# Arboricultural Impact Assessment

Roath Flood Risk Management Scheme  
Roath Brook  
Cardiff

Report Date: 27<sup>th</sup> November 2017

**NB: Revisions from 28-02-2017 version highlighted in cyan**  
**Revisions from 27-11-2017 highlighted in green**

DRAWING NUMBER	REV
624-02.2	C4A

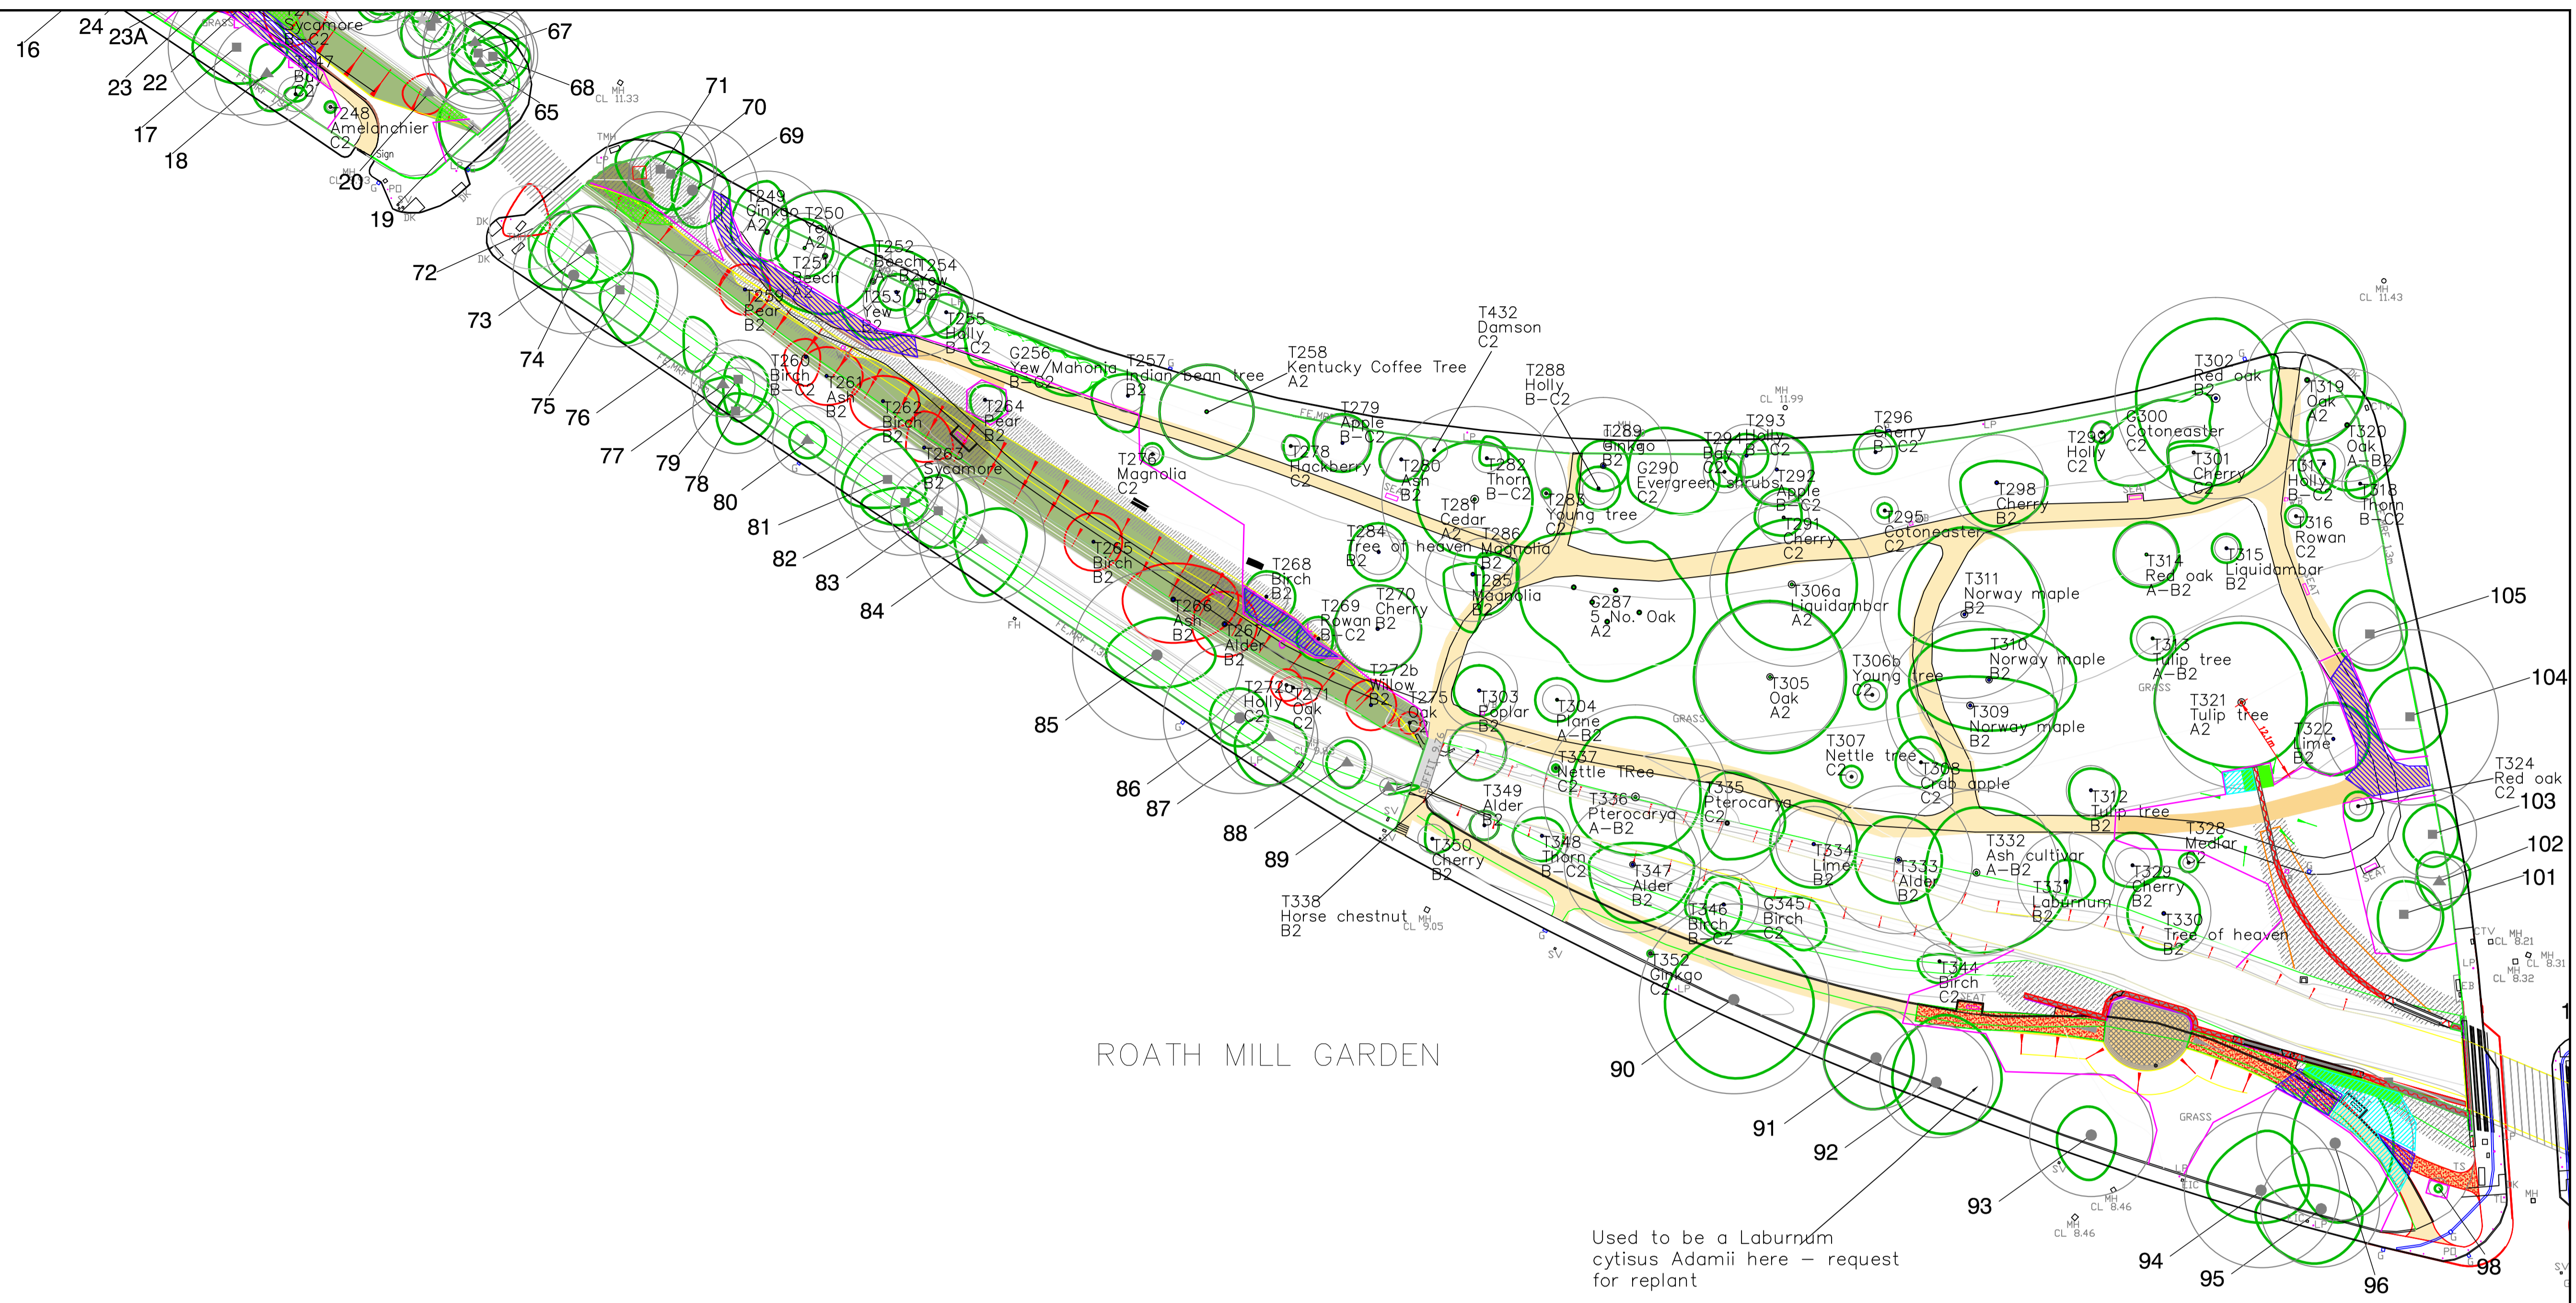
Used to be a Laburnum cytisus Adamii here - request for replant

DRAWING NUMBER	REV
624-02.3	C4A

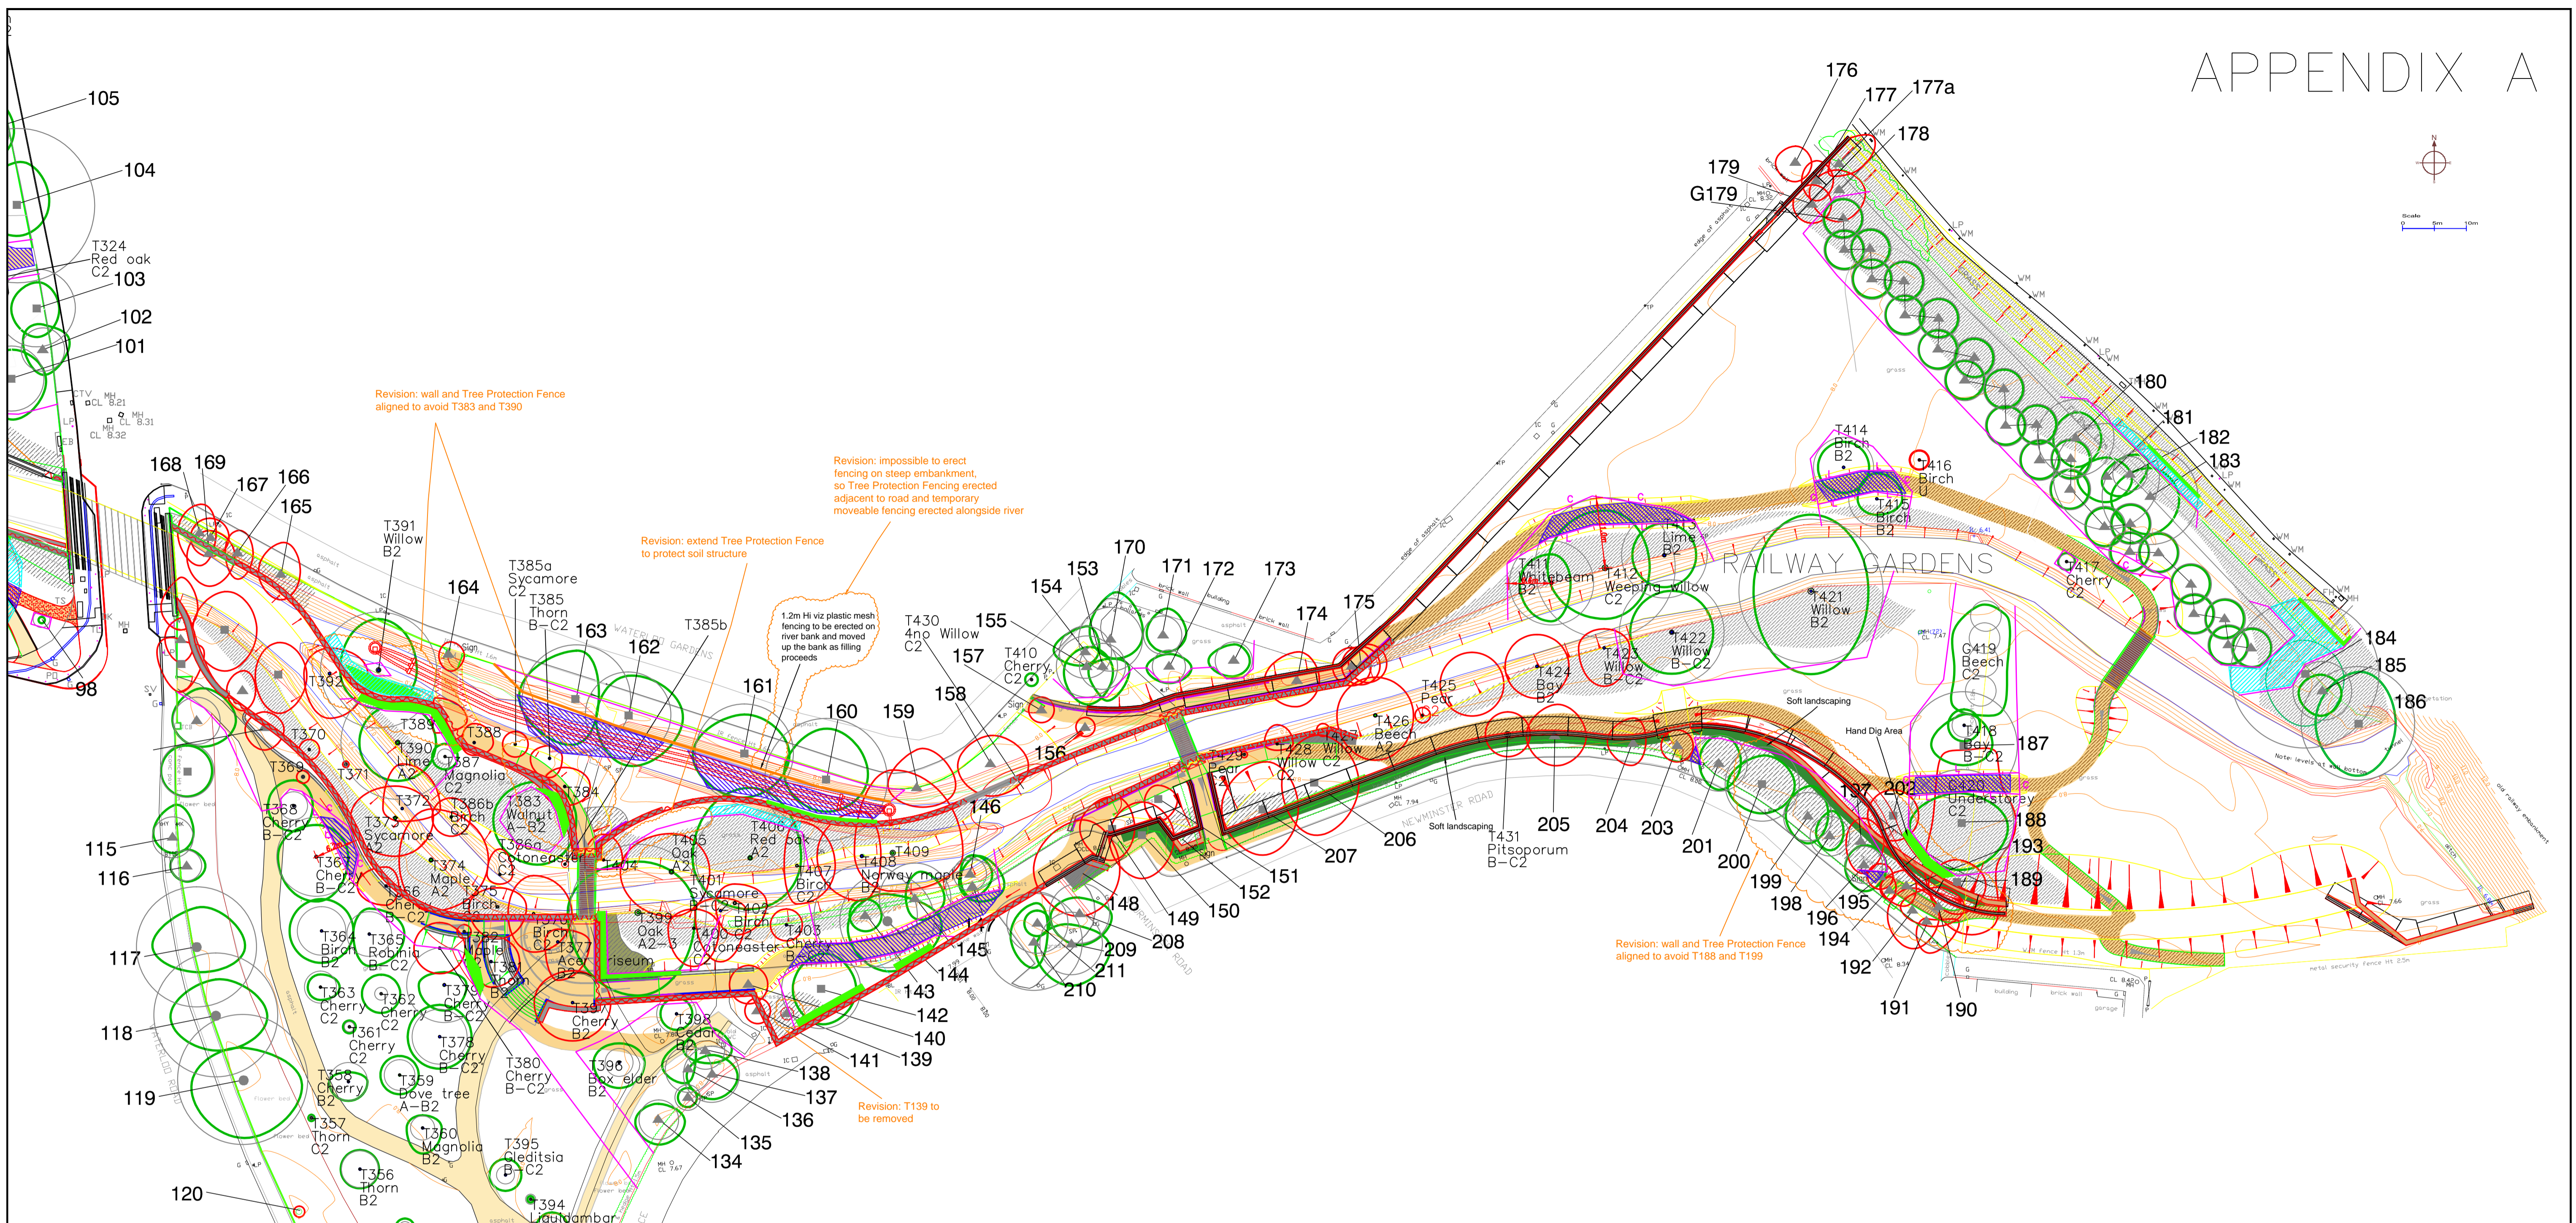
Revision: wall and Tree Protection Fence aligned to avoid T383 and T390

Revision: impossible to erect fencing on steep embankment, so Tree Protection Fencing erected adjacent to road and temporary moveable fencing erected alongside river

Revision: T139 to be removed
